Proposed Revisions to a Standard Plans Index

Date: February 2, 2022 Originator: James McGinnis Index Number: 102-615 Sheet Number (s): 1-5 of 5

Index Title: Multilane Roadway, Intersection Work

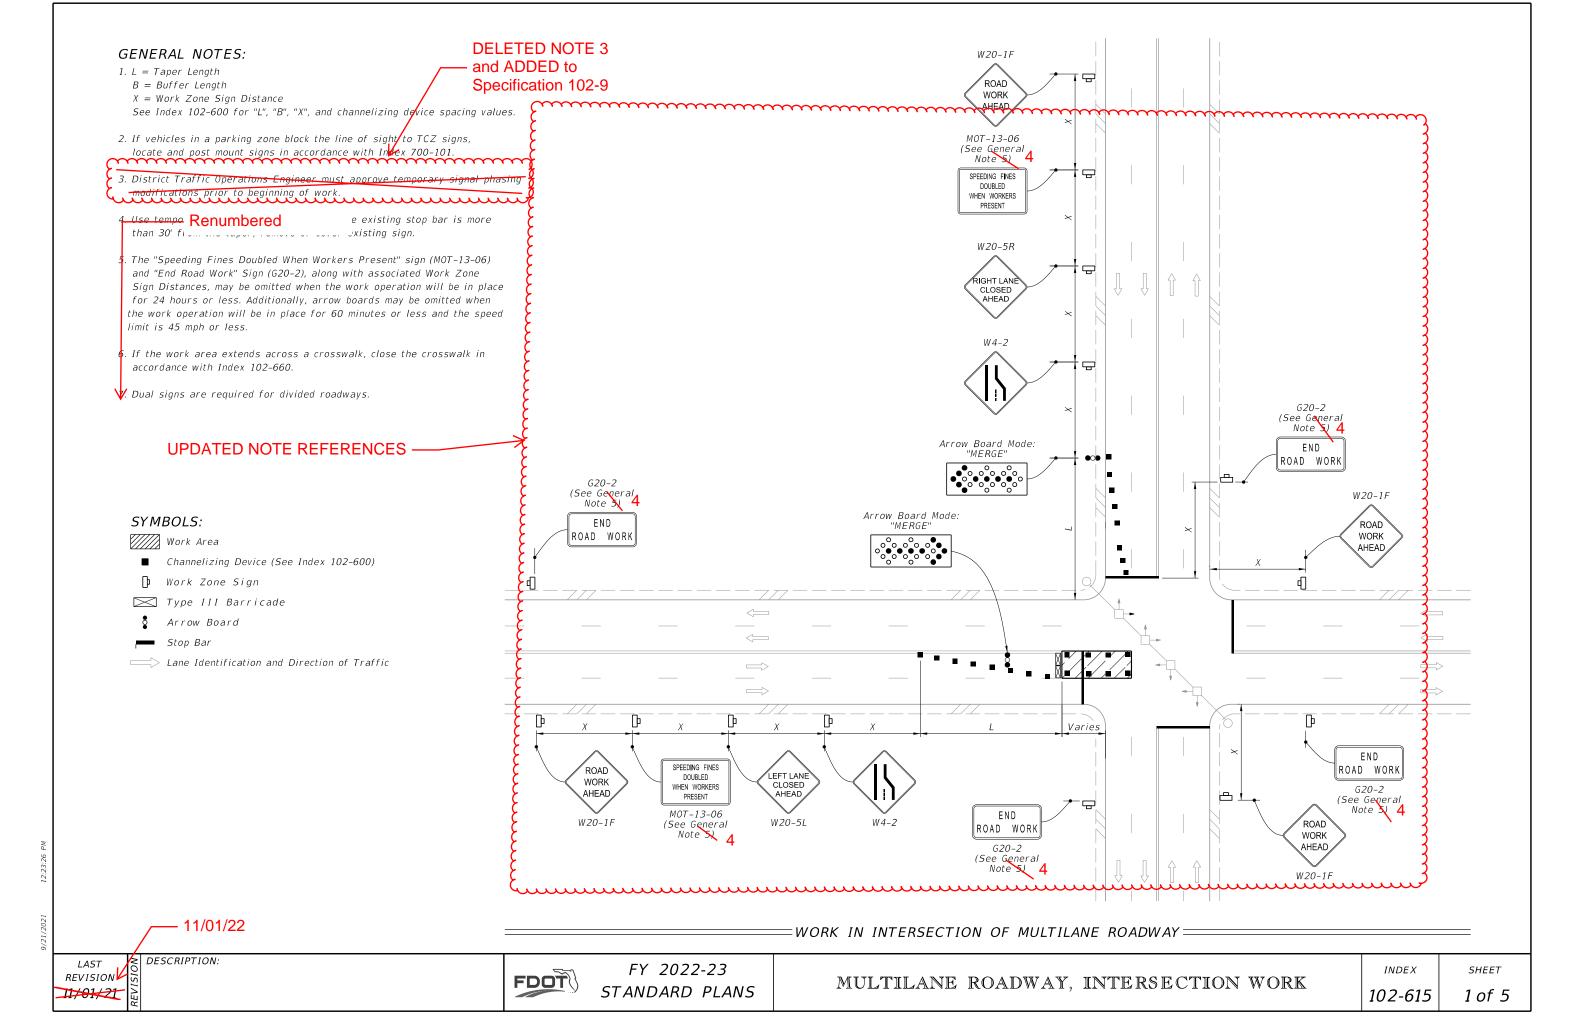
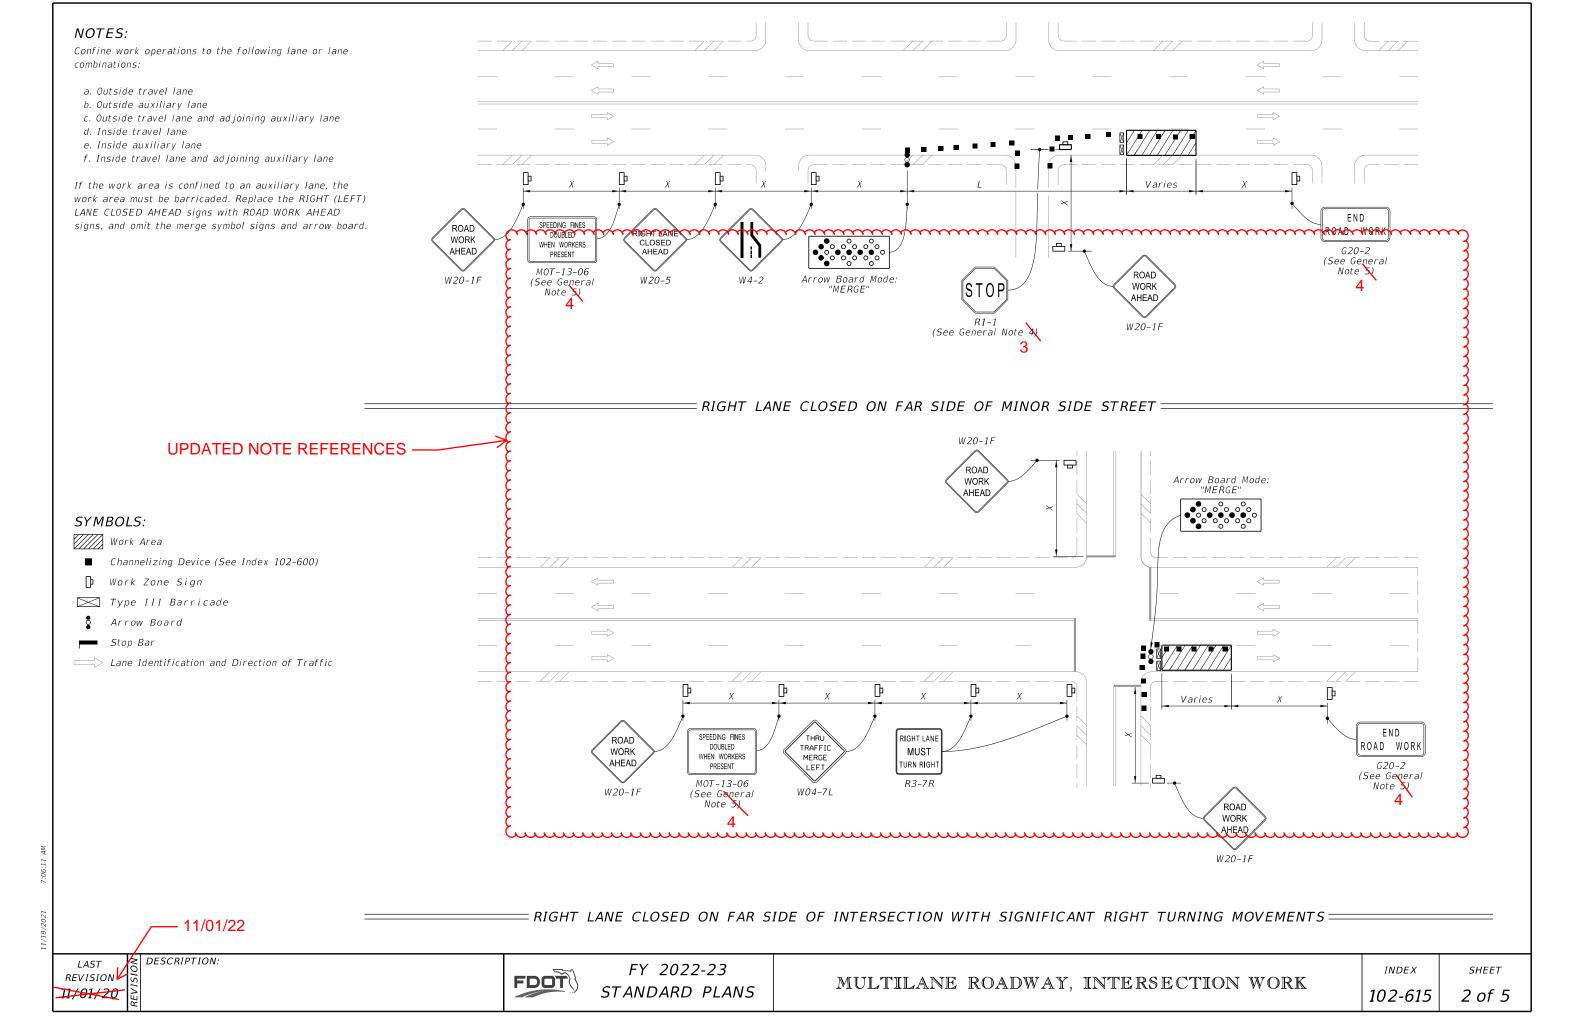
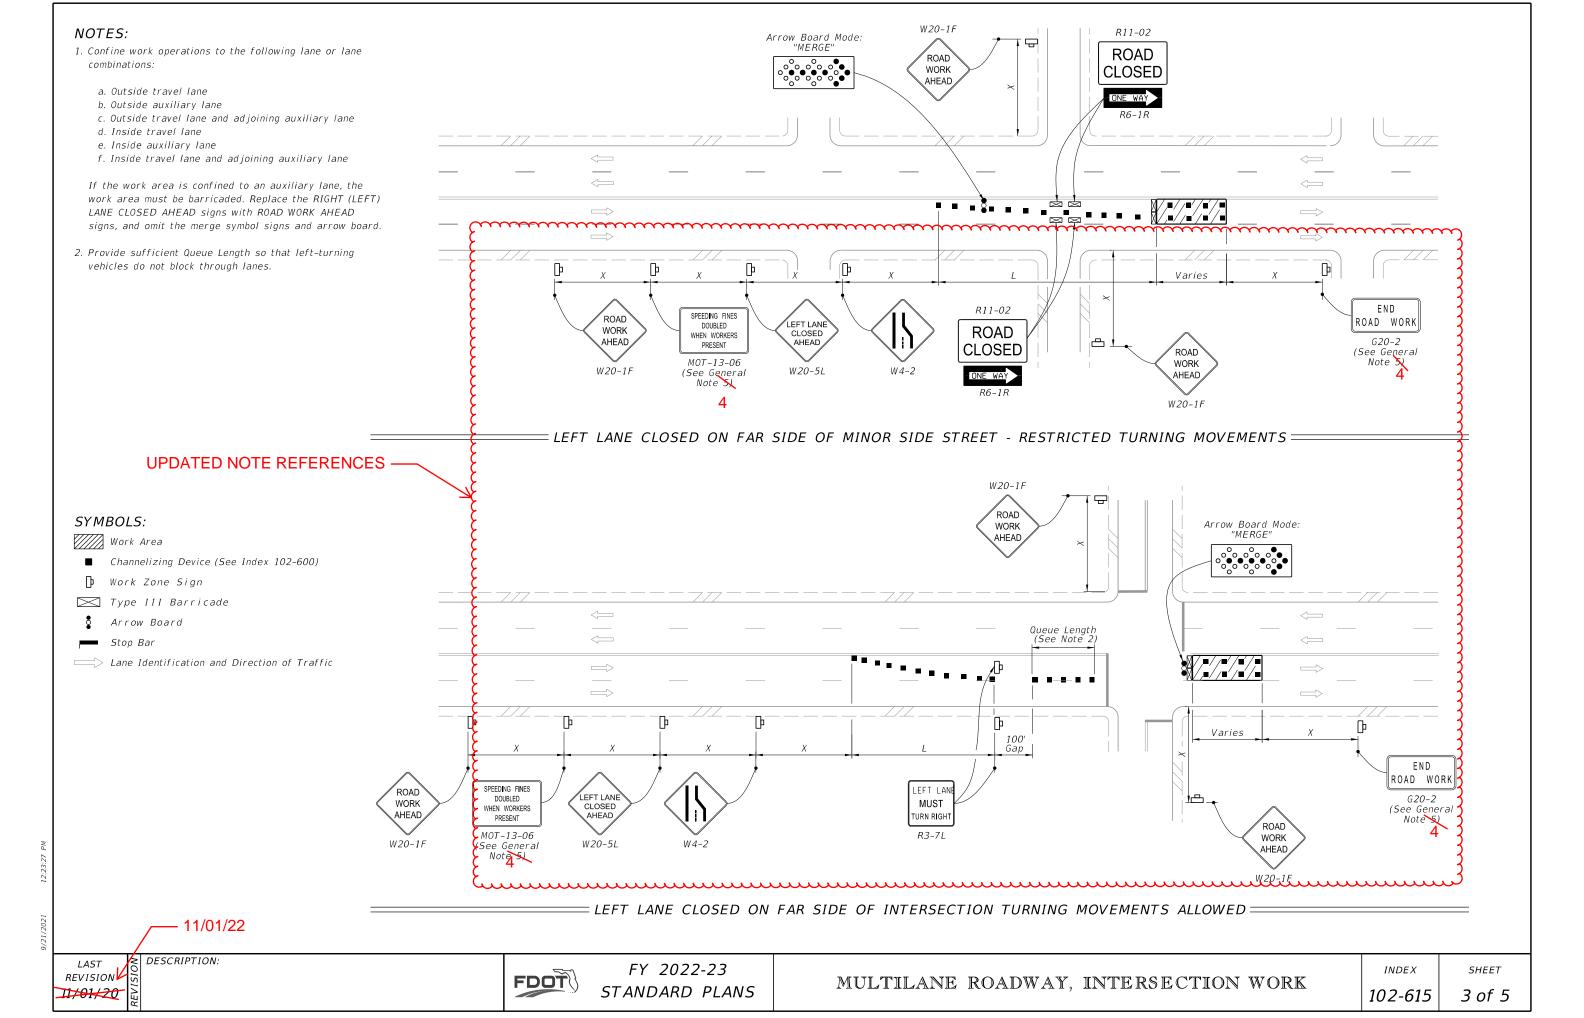
Sheet 1: Deleted Note 3 "District Traffic Operations Engineer must approve temporary signal phasing modifications prior to beginning or work" and added to Specification 102-9; Updated the Note callouts references in the details.

The note was moved to the Specifications to provide guidance to the contractor in one area for all temporary signal timing.
